<b>DOCKET</b>	
<b>06-AAER-1</b>	
<b>DATE</b>	<b>APR 17 2006</b>
<b>RECD.</b>	<b>APR 19 2006</b>

NATURAL RESOURCES DEFENSE COUNCIL

External Power Supply Documentation from NRDC

**External Power Supply Examples  
for Various Products Covered by  
the CEC Title 20 Regulations**

# Example 1 – Groomsman cord/cordless

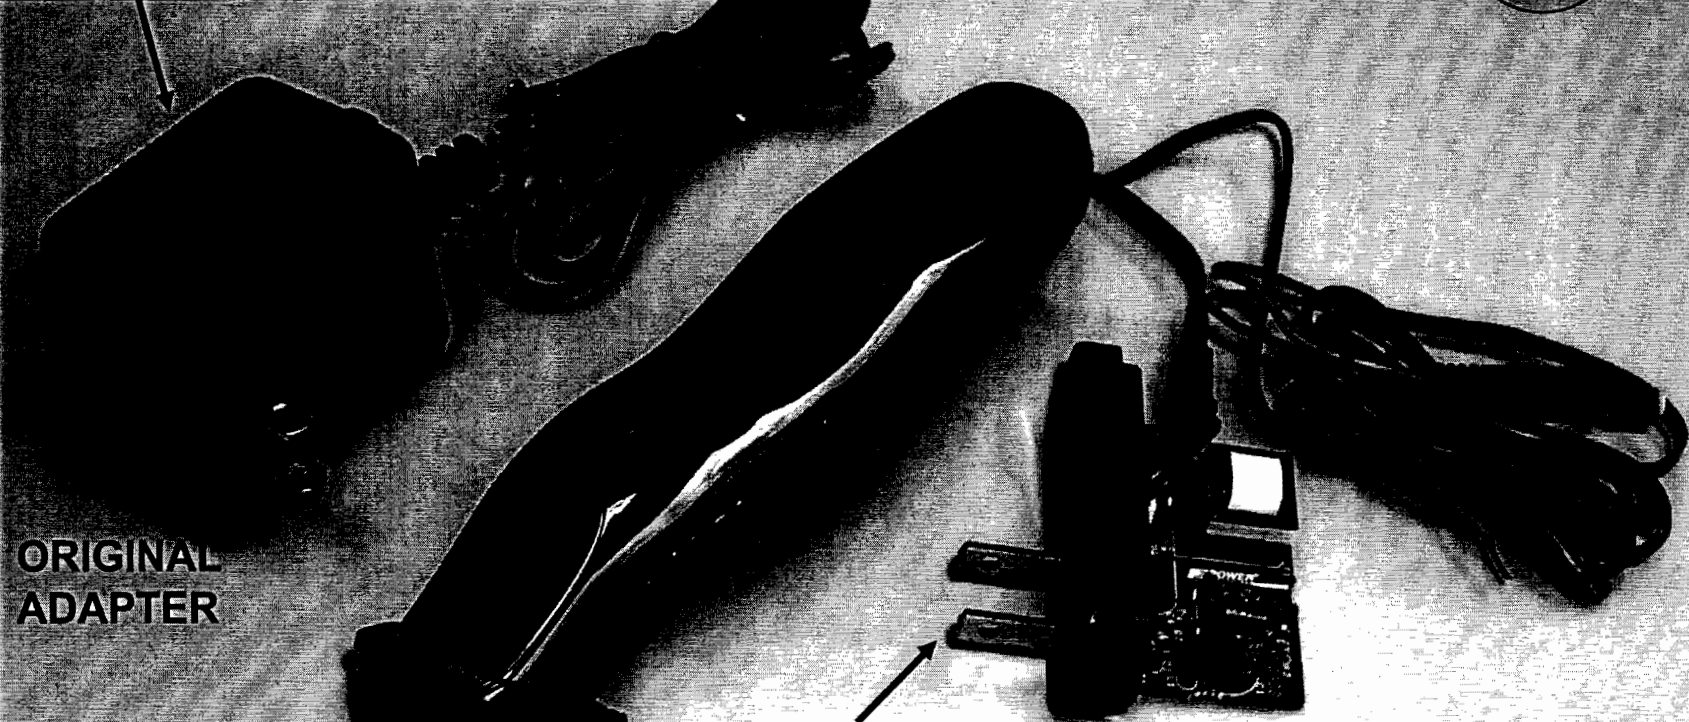
**Image 1 – Wahl Groomsman Clipper**

The EPS in the upper left corner is the linear EPS that is provided with the current Groomsman model clipper. The guts of a prototype switch mode EPS is provided on the right. The average efficiency of the switcher is more than double that of the currently supplied EPS.

NAMEPLATE SPEC 3Volts @ 0.2Amps (0.6Watts)			
	PERFORMANCE	CEC REQUIREMENT	PASS/FAIL
No-Load	1.19W	0.50W	FAIL
Ave Active Efficiency	27.6%	29.4%	FAIL

NAMEPLATE SPEC 3VOLTS @ 0.2Amps (0.6Watts)			
	PERFORMANCE	CEC REQUIREMENT	PASS/FAIL
No-Load	0.08W	0.50W	PASS
Ave Active Efficiency	66.3%	29.4%	PASS

Estimate Cost Difference \$0.2 - \$0.4

## Example 5 – Shaver

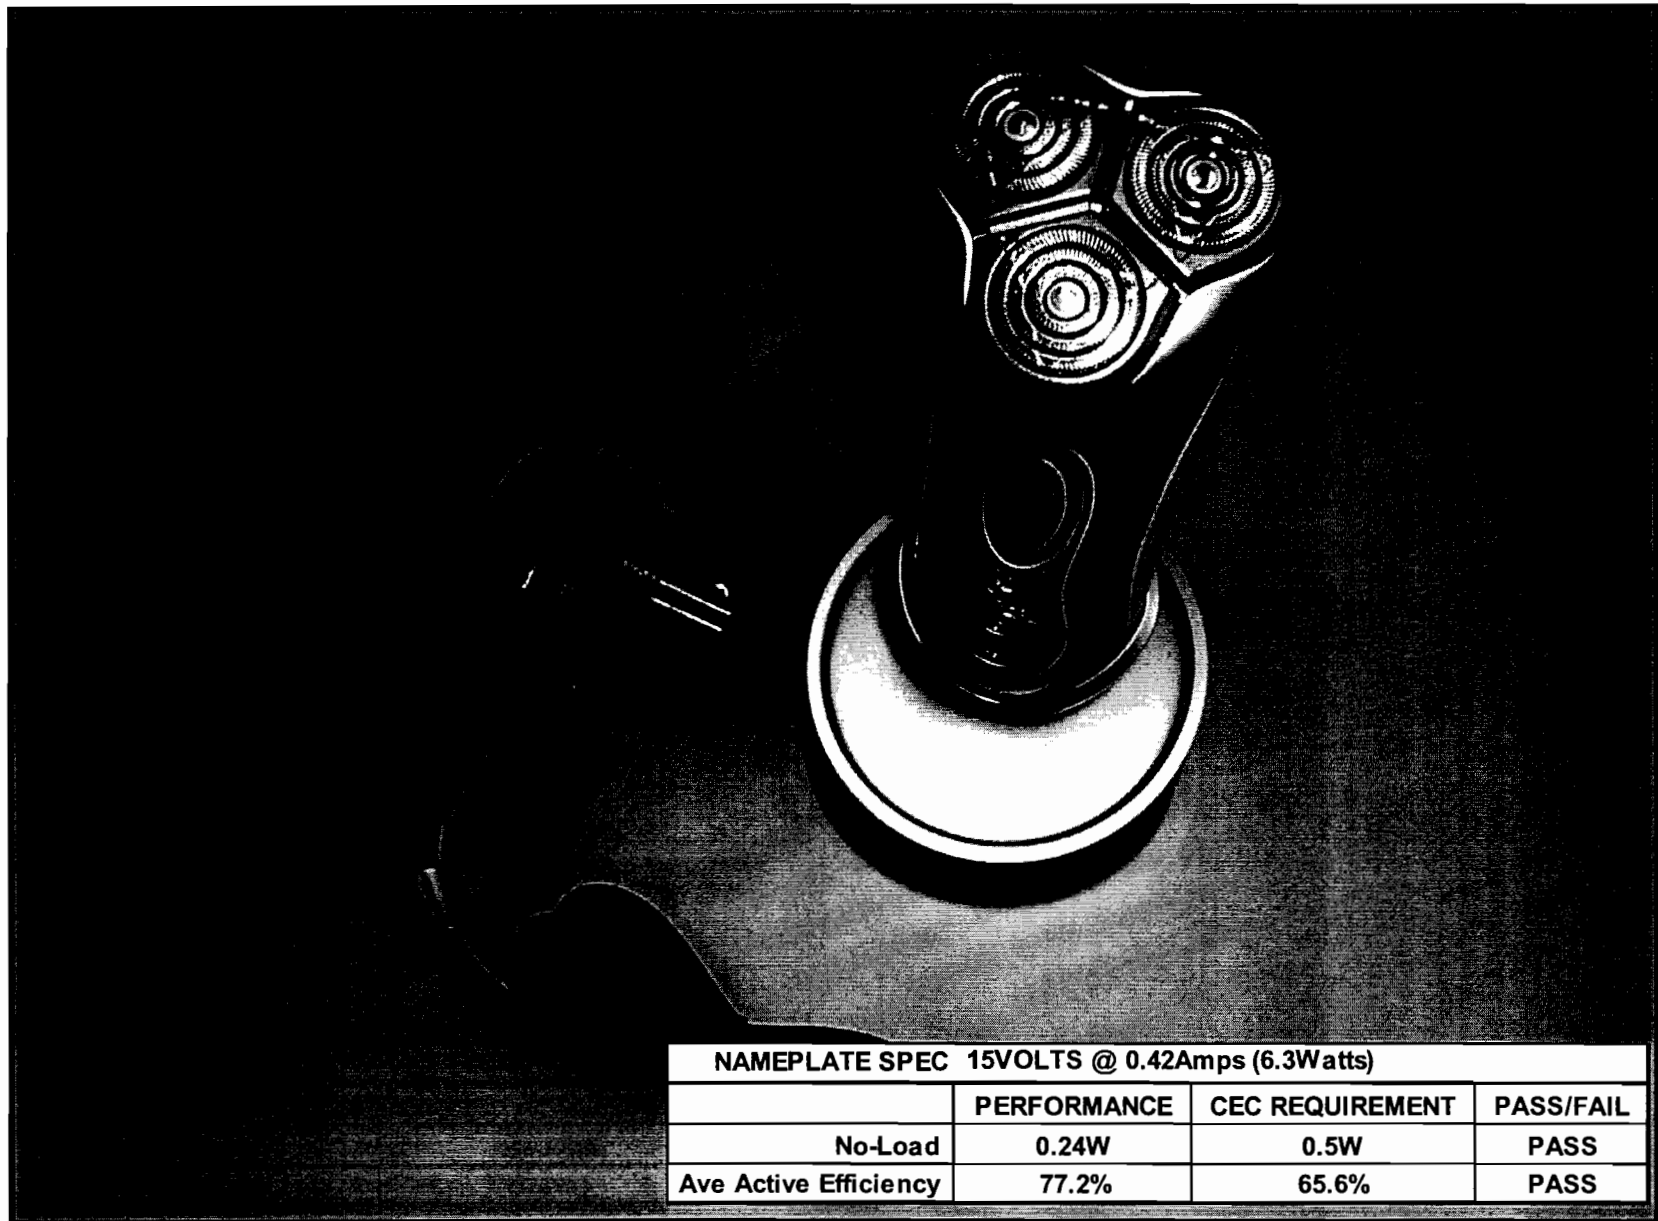
#### Image 5 – Philips Norelco Shaver

We provide this as an example of a shaver purchased at retail that already meets the CEC EPS requirements. It is currently shipped with a CEC compliant switch mode EPS.

NAMEPLATE SPEC 15VOLTS @ 0.42Amps (6.3Watts)			
	PERFORMANCE	CEC REQUIREMENT	PASS/FAIL
No-Load	0.24W	0.5W	PASS
Ave Active Efficiency	77.2%	65.6%	PASS
